Form C-103
Revised July 18, 2013

WELL API NO. 30-015-55116	
5. Indicate Type of Lease STATE ☐ FEE ☒	
6. State Oil & Gas Lease No.	
7. Lease Name or Unit Agreement Name YARDBIRDS 34/3 FEE	
8. Well Number	715H
9. OGRID Number	14744
10. Pool name or Wildcat PURPLE SAGE;WOLFCAMP (GAS)	
11. Elevation (Show whether DR, RKB, RT, GR, etc.) 3043' GR

2. Name of Operator
MEWBOURNE OIL CO

Mewbourne Oil Company requests that the following changes be made to the approved APD for the Yardbirds 34/3 Fee #715H (API: 30-015-55116):

WELL LOCATION AND ACREAGE DEDICATION PLAT

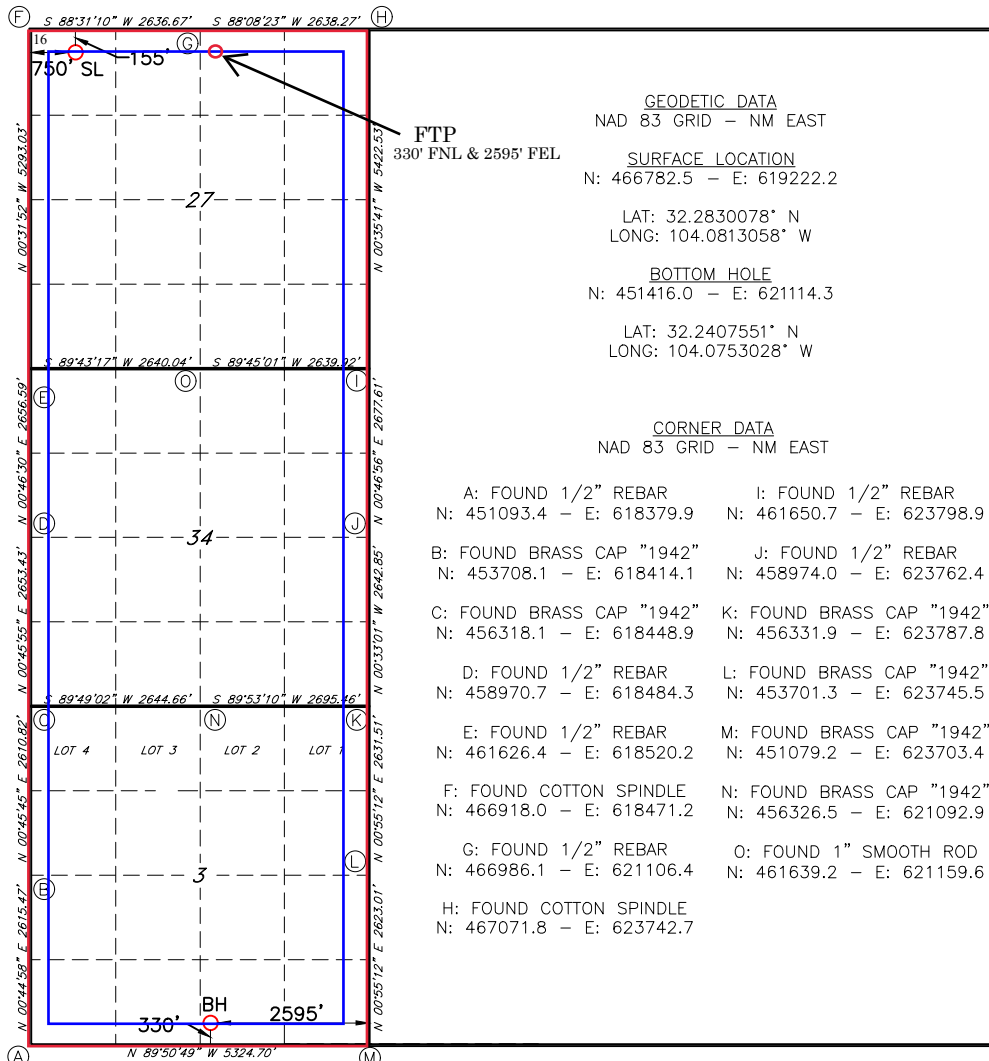
- Change well name from Yardbirds 34/3 Fee #715H to Yardbirds 27/3 Fee #715H.
- Change SHL from 2400' FSL & 1840' FWL (Sec 34) to 155' FNL & 750' FWL (Sec 27).
- Change BHL from 330' FSL & 2530' FEL (Sec 3) to 330' FSL & 2595' FEL (Sec 3).
- Change Surface Casing set depth from 1200' to 450'.
- Change Production Casing from 7" 26# P110 LTC to 7 5/8" 29.7# HCP110 GBCD.
- Change Liner from 4.5" 13.5# P110 LTC to 5.5" P110 Talon.

UL or lot no.	Section	Township	Range	Lot Idn	Feet from the	North/South line	Feet From the	East/West line	County
D	27	23S	28E		155	NORTH	750	WEST	EDDY

UL or lot no.	Section	Township	Range	Lot Idn	Feet from the	North/South line	Feet from the	East/West line	County
0	3	24S	28E		330	SOUTH	2595	EAST	EDDY
¹² Dedicated Acres 1920	¹³ Joint or Infill	¹⁴ Consolidation Code	¹⁵ Order No.

Mewbourne Oil Company, Yardbirds 27/3 Fee 715H

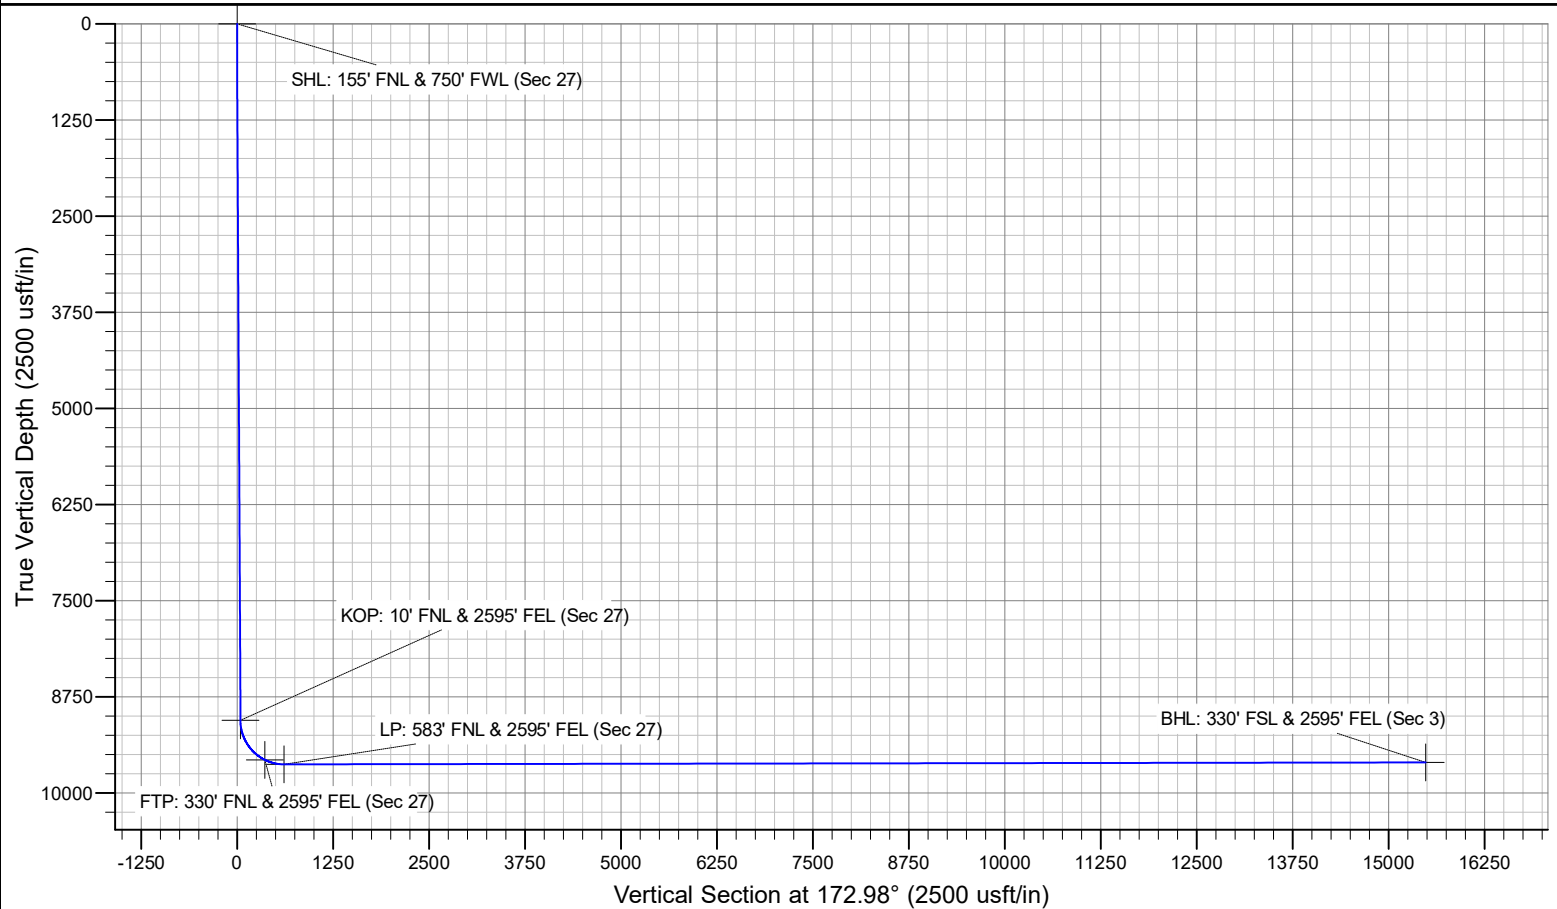
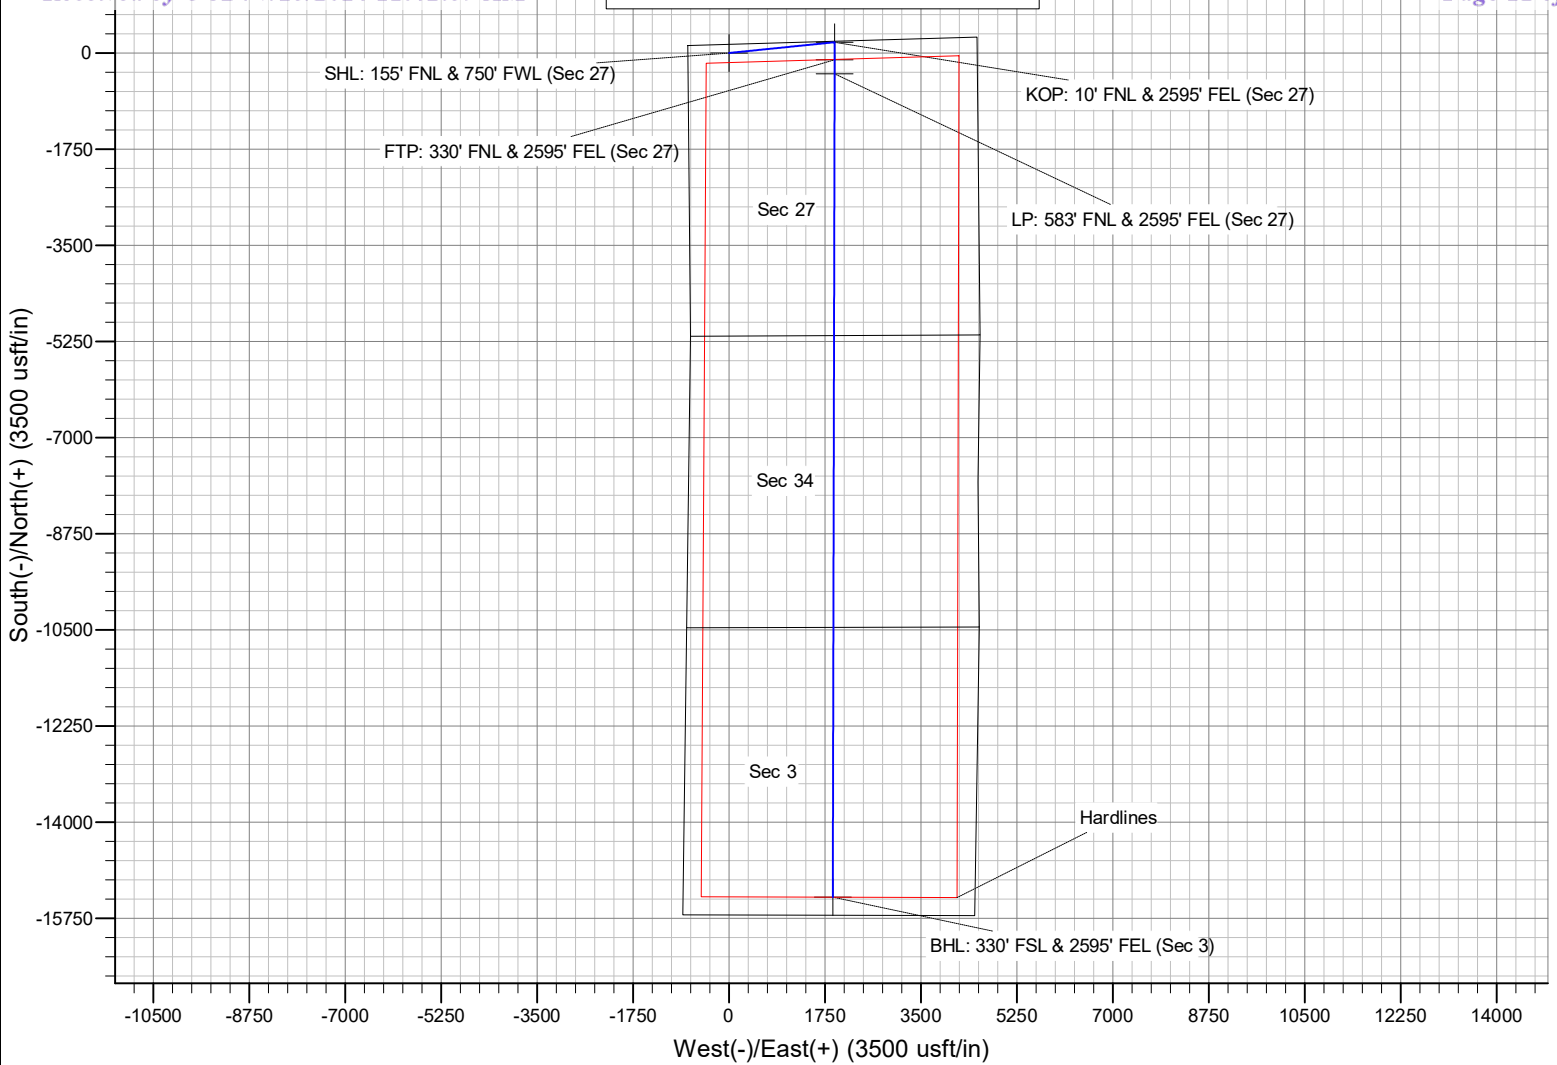
Attached is the C102, Casing Assumptions, Directional Plot and Plan that details the above changes.

Created By	Condition	Condition Date
ward.rikala	All original COA's still apply. Surface casing must be sat and cemented minimum 20' into the Rustler formation Additionally, if cement is not circulated to the surface during cementing operations, then a CBL is required.	8/15/2024
